Addendum No. 1

RE: Contract # C205036

Robeson County (U-5797)

SR-1997 (FAYETTEVILLE RD) FROM FARRINGDOM ST TO EAST 22ND ST

SHEET NO.
8

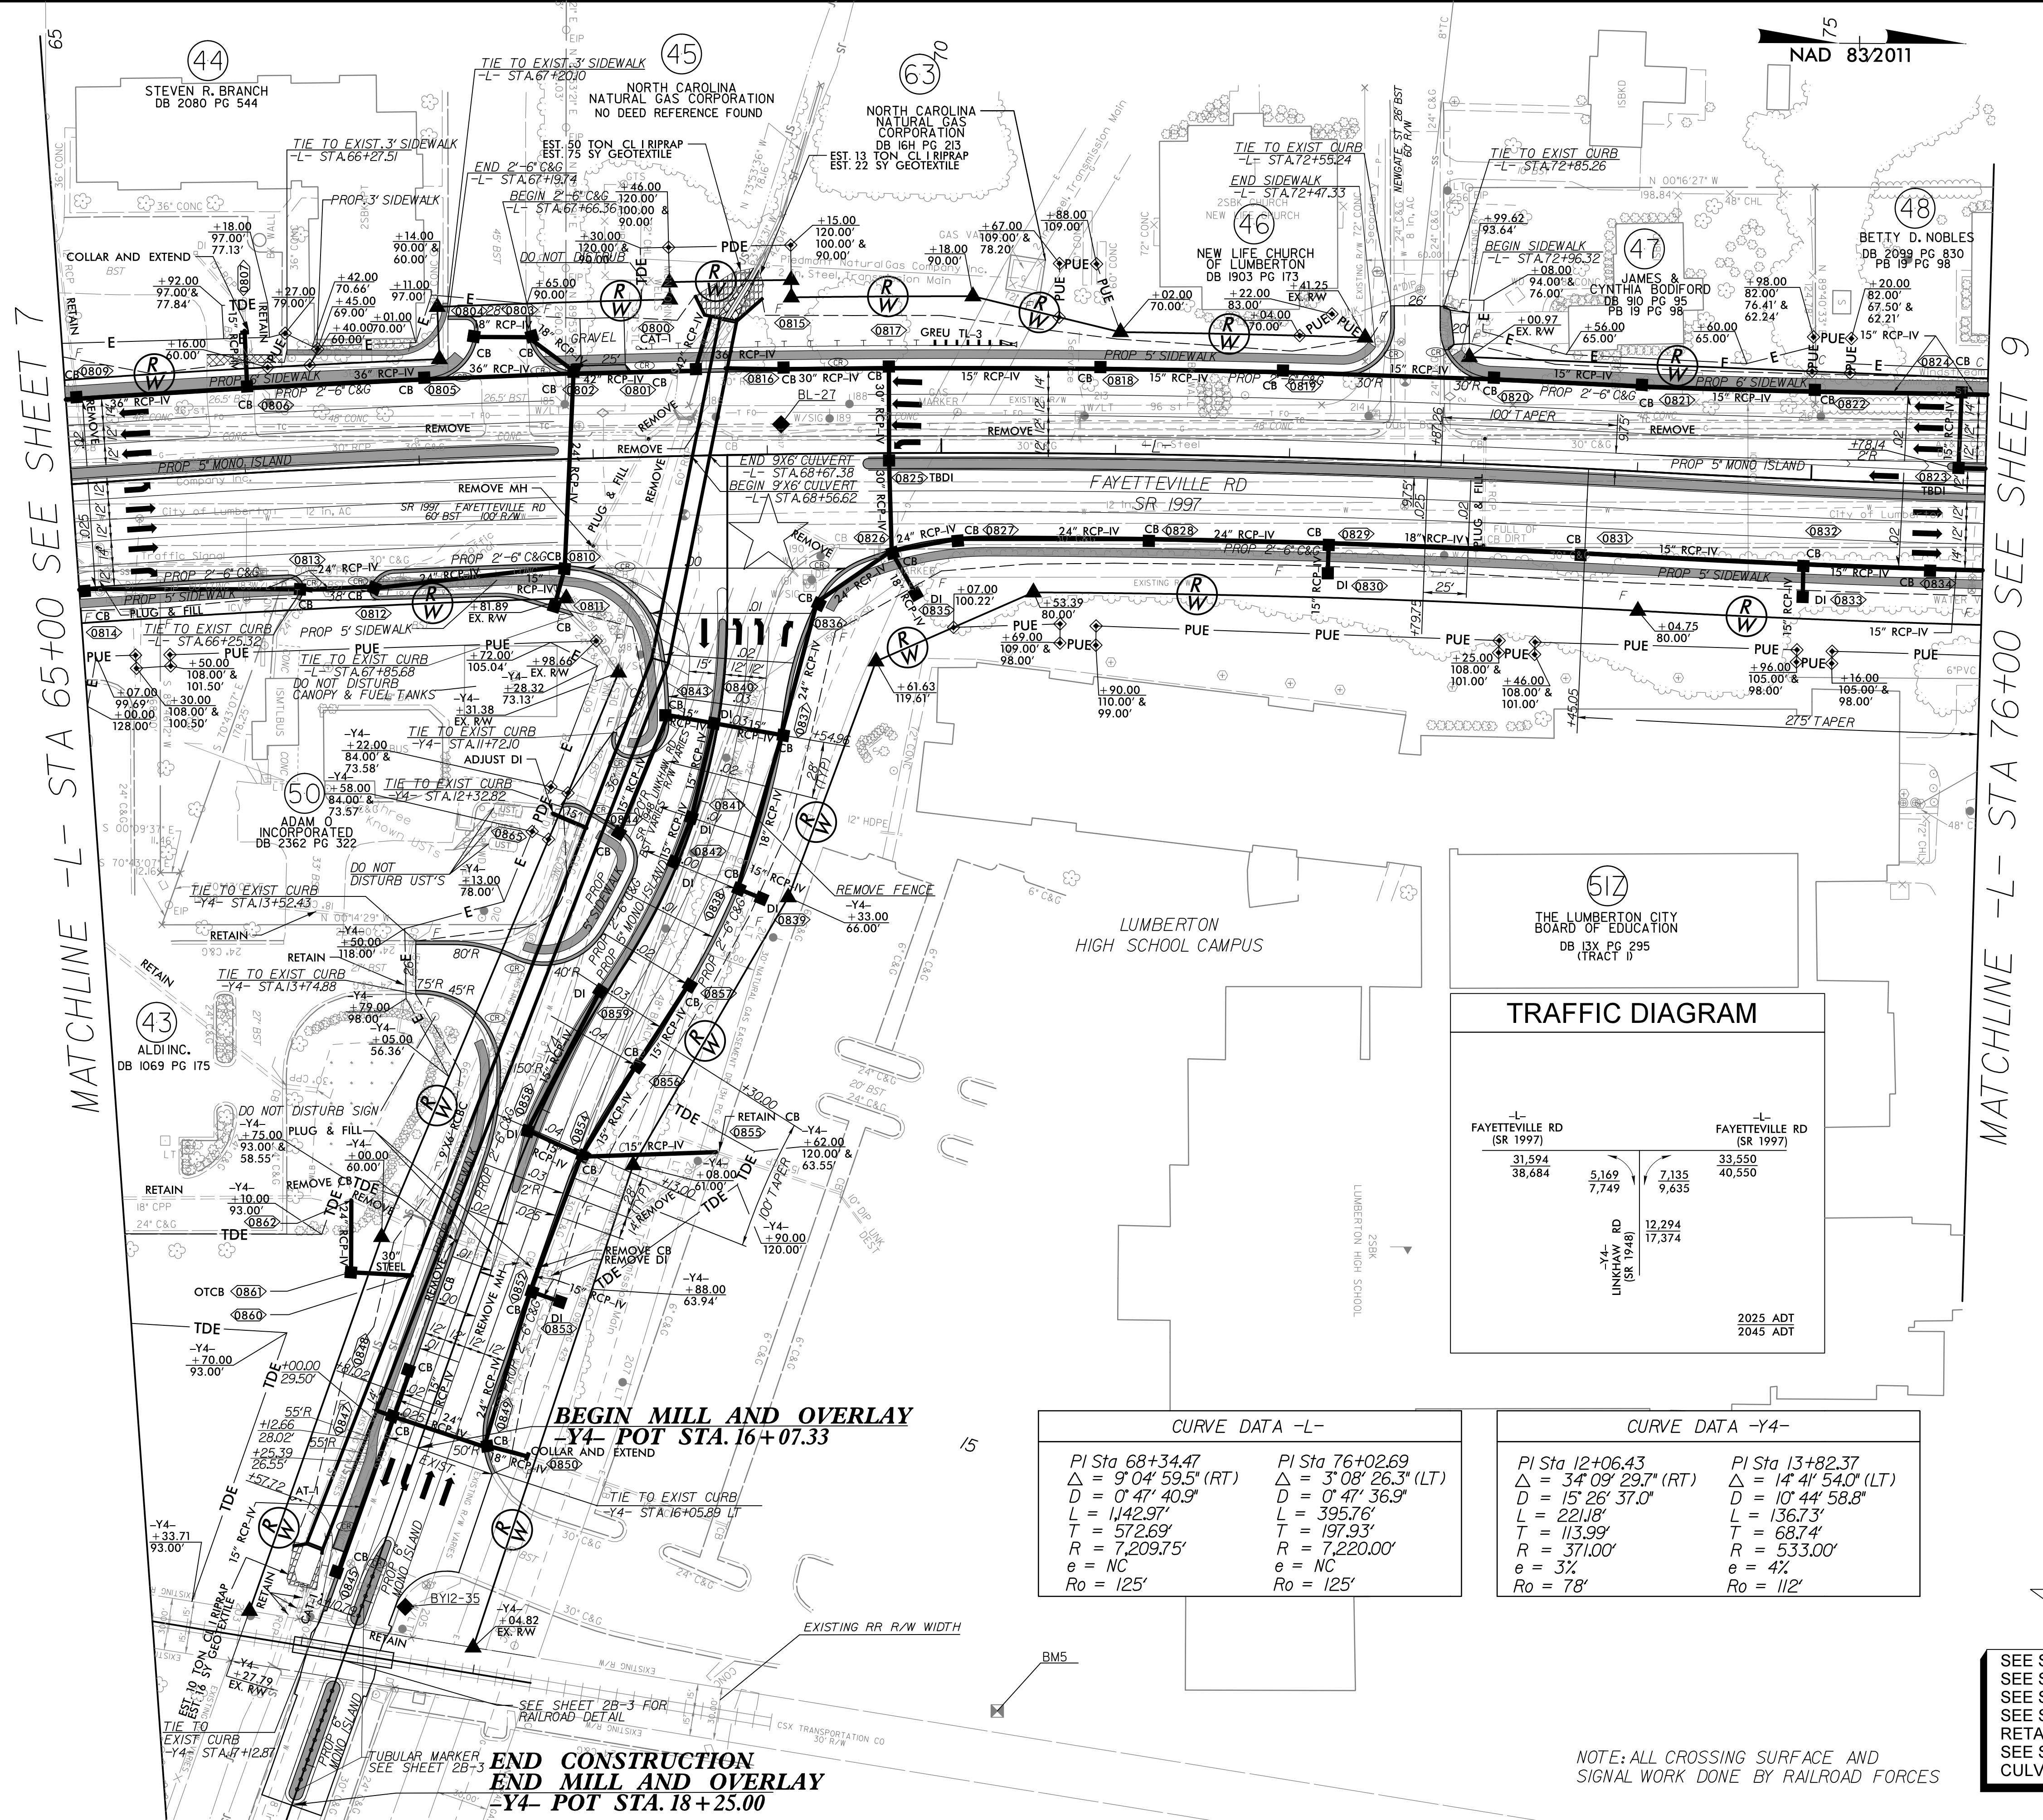
3D-14	Revised totals for boxes, pipes, and pipes removal
8	Removed Rail Road hatching from plan sheet. Island shortened to be outside of Railroad ROW
11	Design Updated to end at the Railroad
16	Design Updated to end at the Railroad

PROJ. REFERENCE NO.	SHEET NO.
U-5797	TMP-22

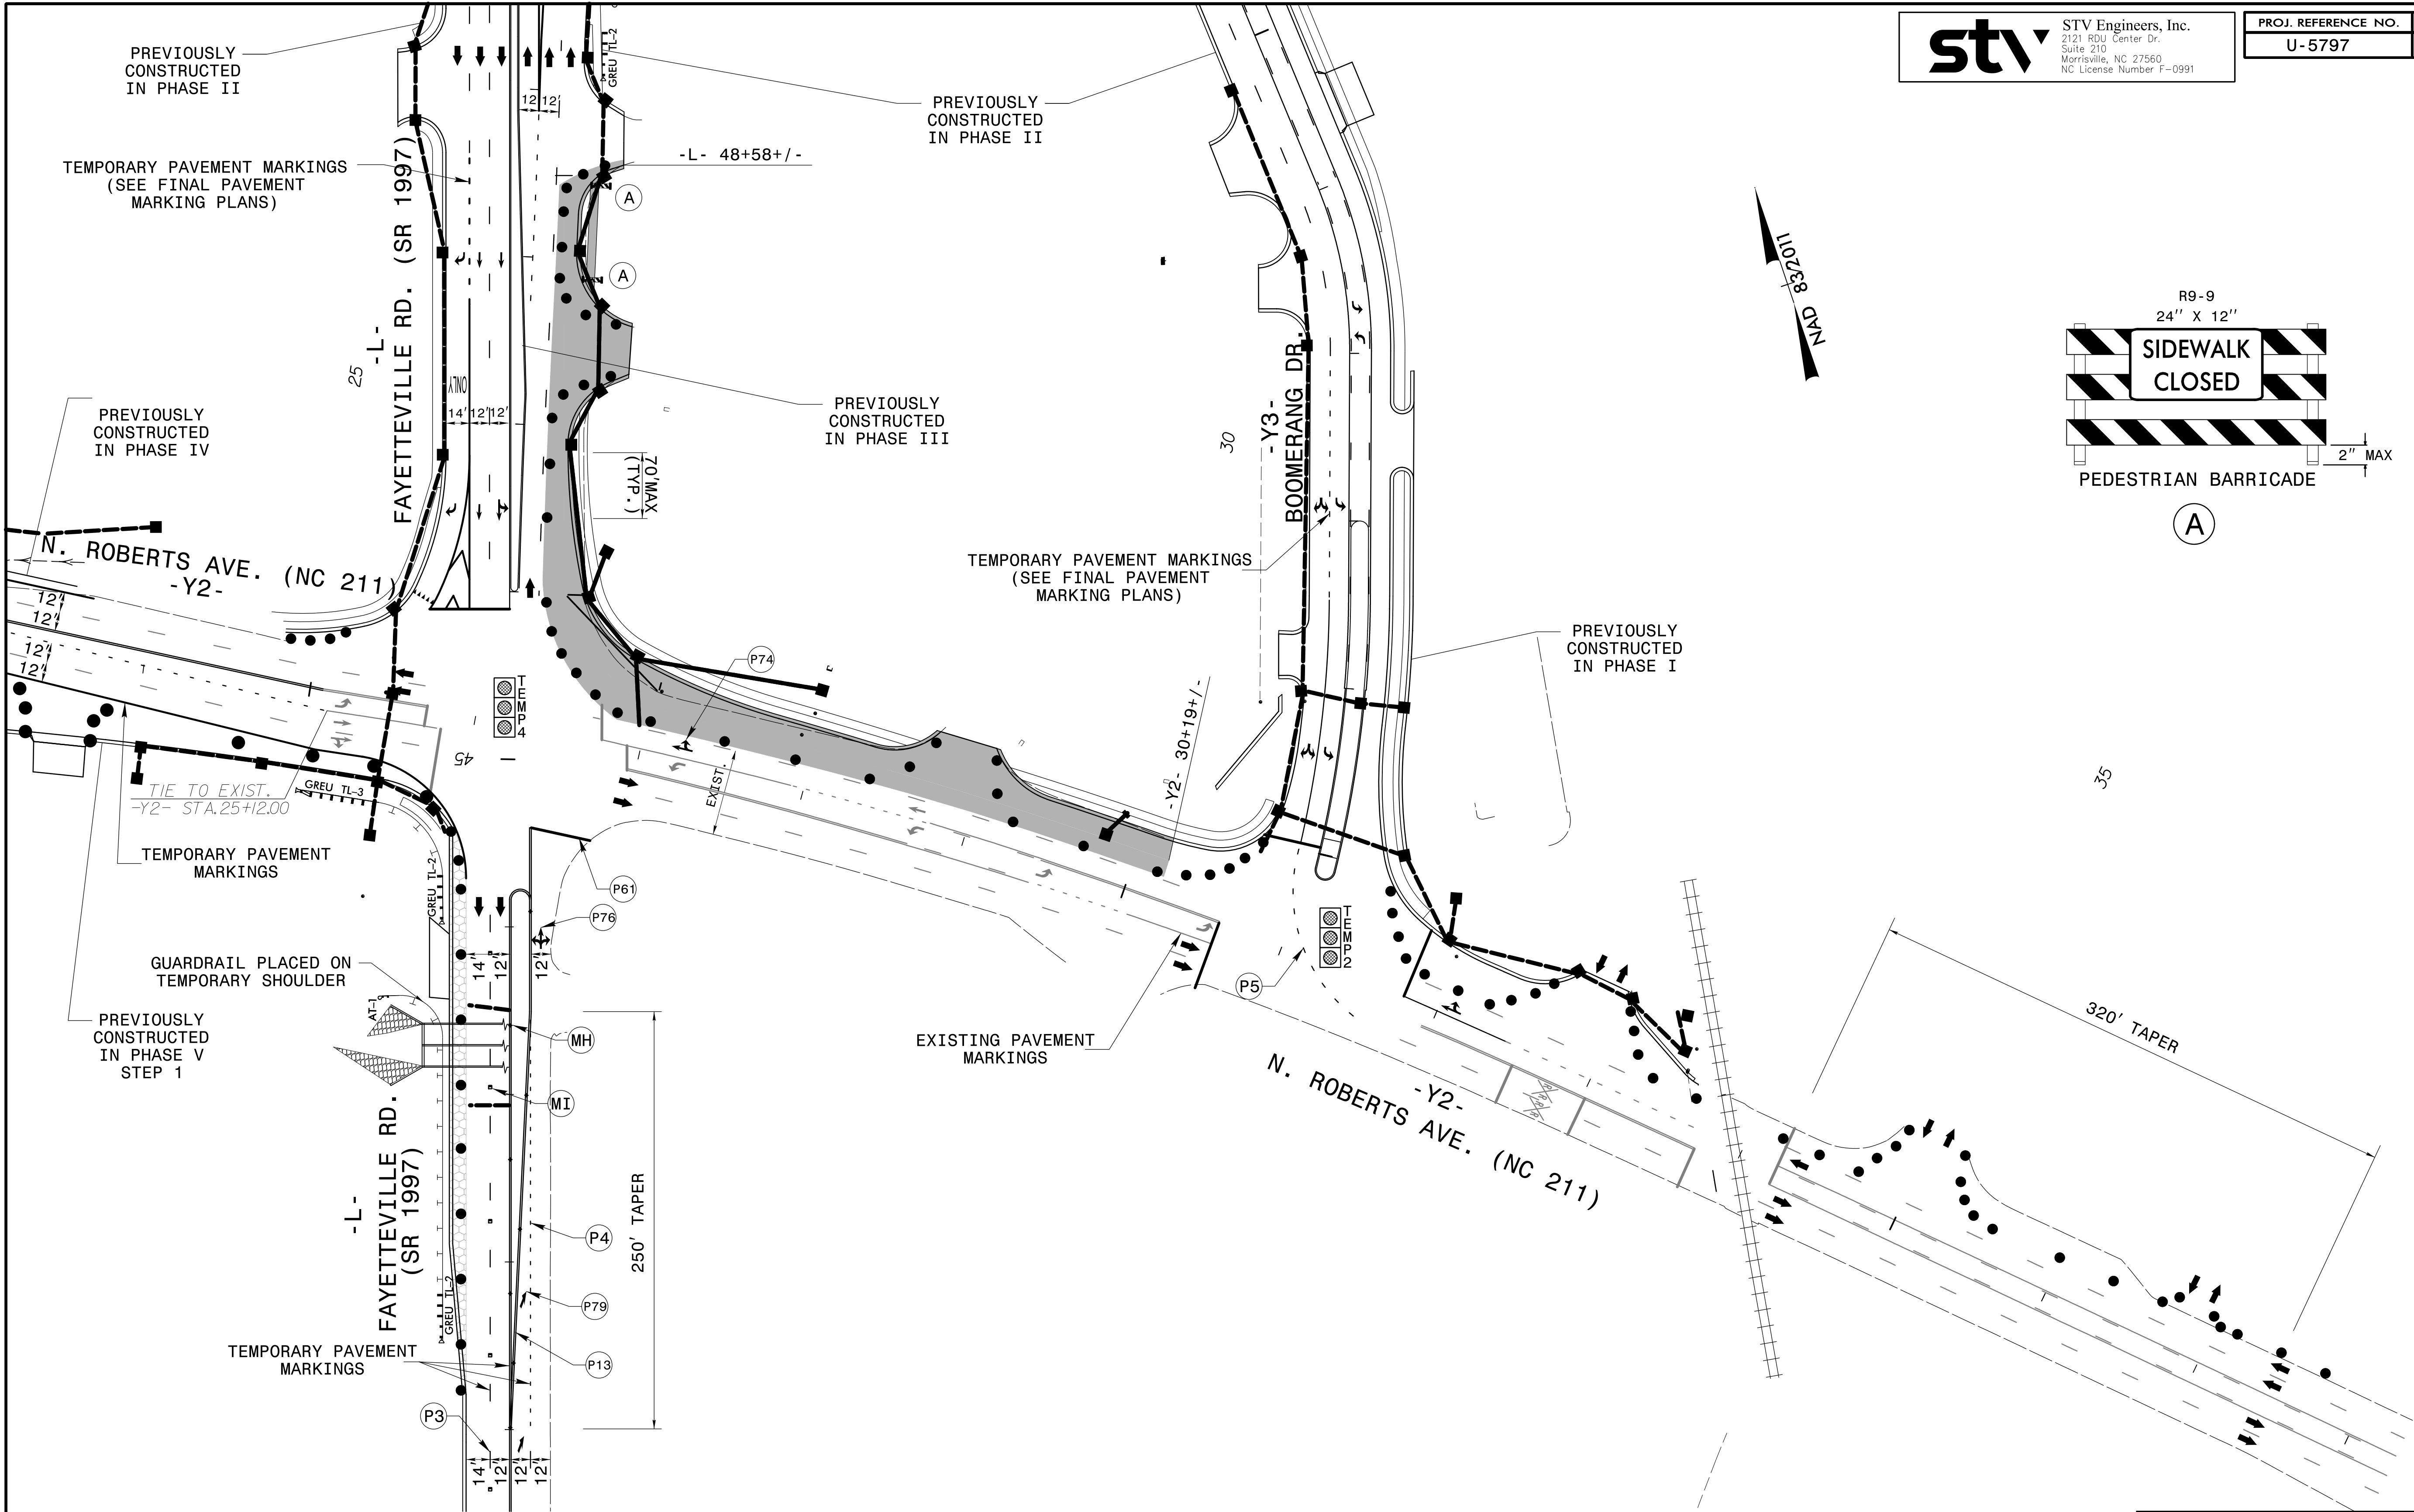
Sheet No.	Revision
TMP-2A-1	updated Y2 station to match the updated RDY plans
TMP-2A-2	updated Y2 station to match the updated RDY plans
TMP-3	updated Y2 design to match the updated RDY plans
TMP-22	updated Y2 design to match the updated RDY plans
TMP-25	updated Y2 design to match the updated RDY plans

PROJ. REFERENCE NO.	SHEET NO.
U-5797	PMP-9

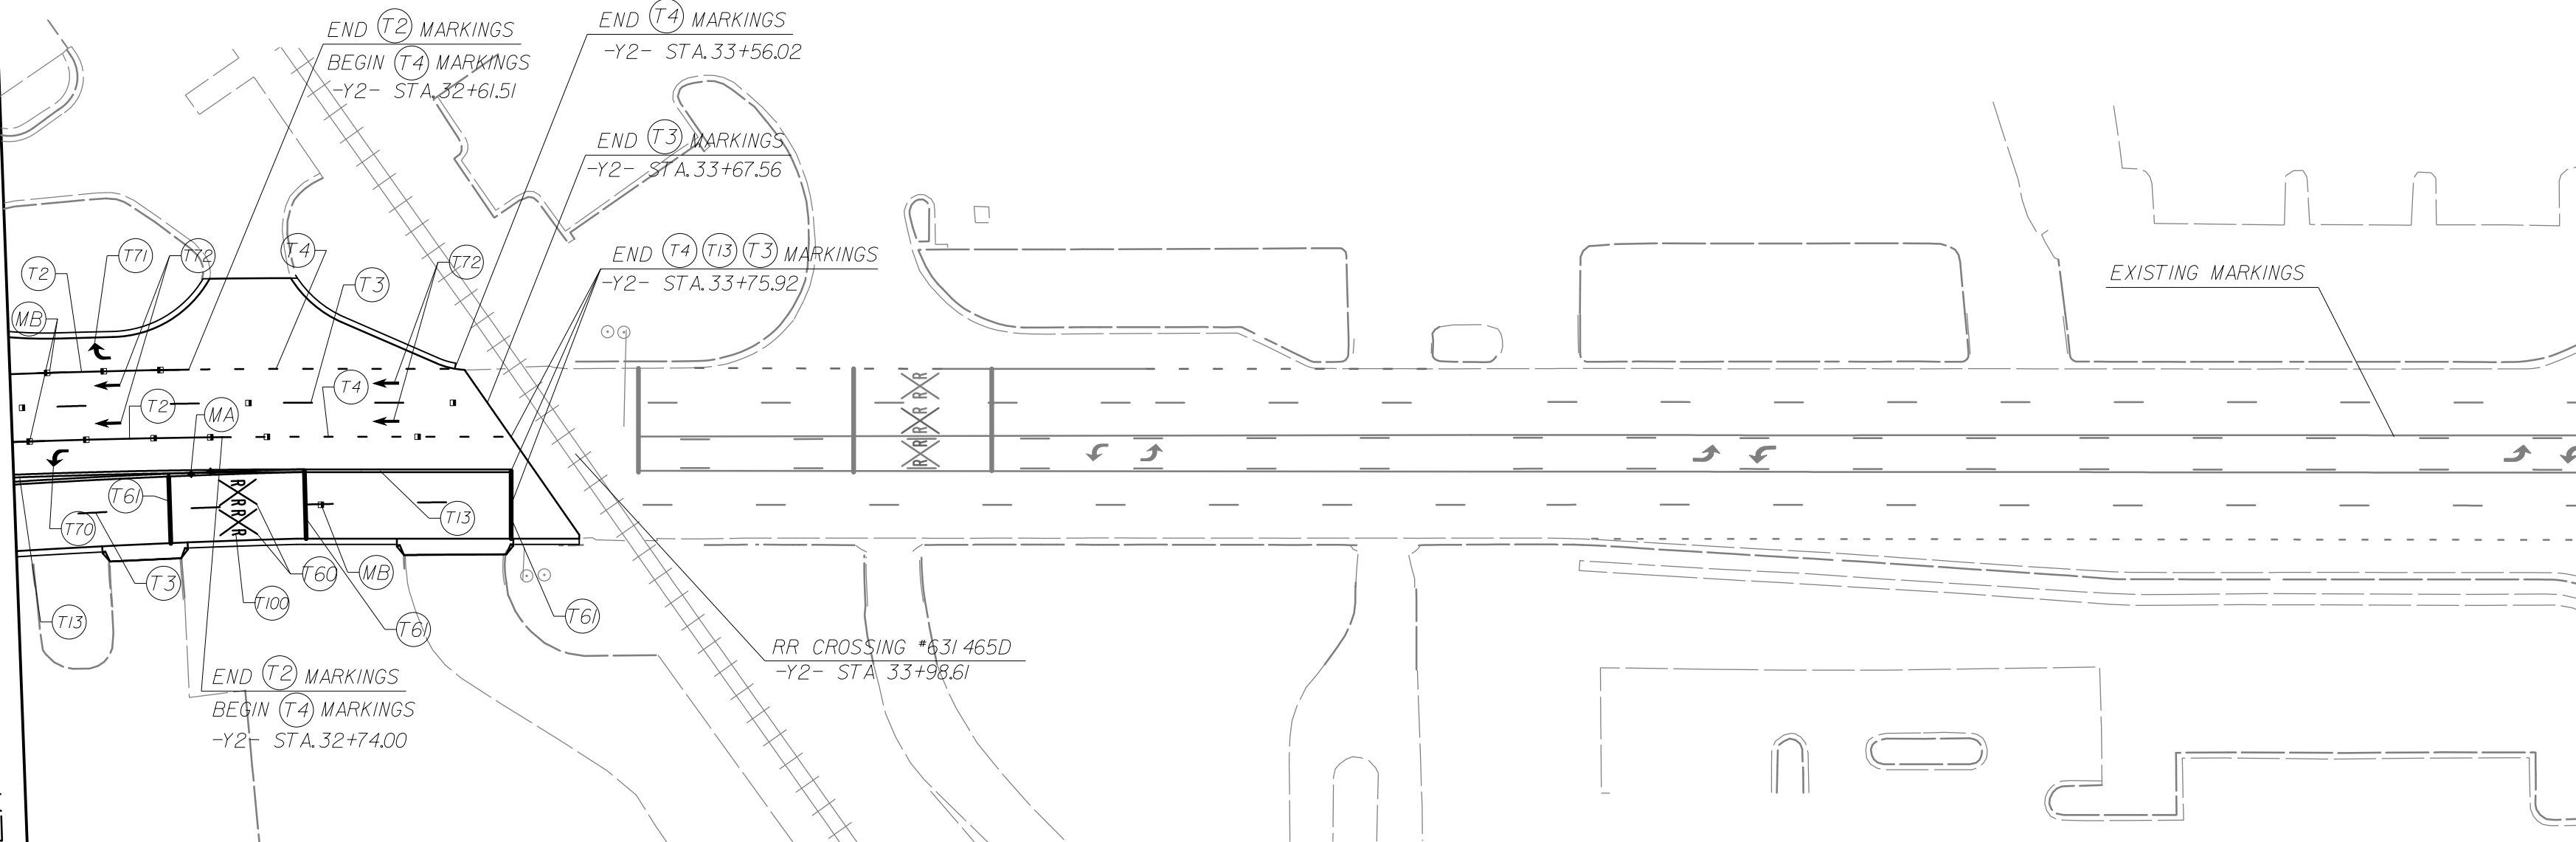
Sheet No.	Revision
PMP-9	Updated pavement markings to match the updated roadway design
